Super 8

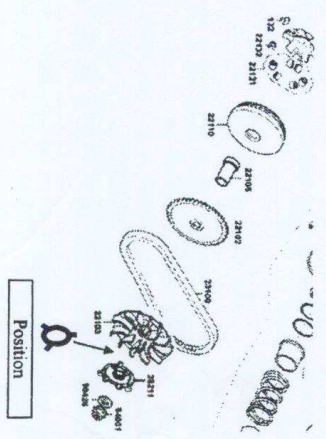
(3) CDI CUT V/R COLOR WIRE:
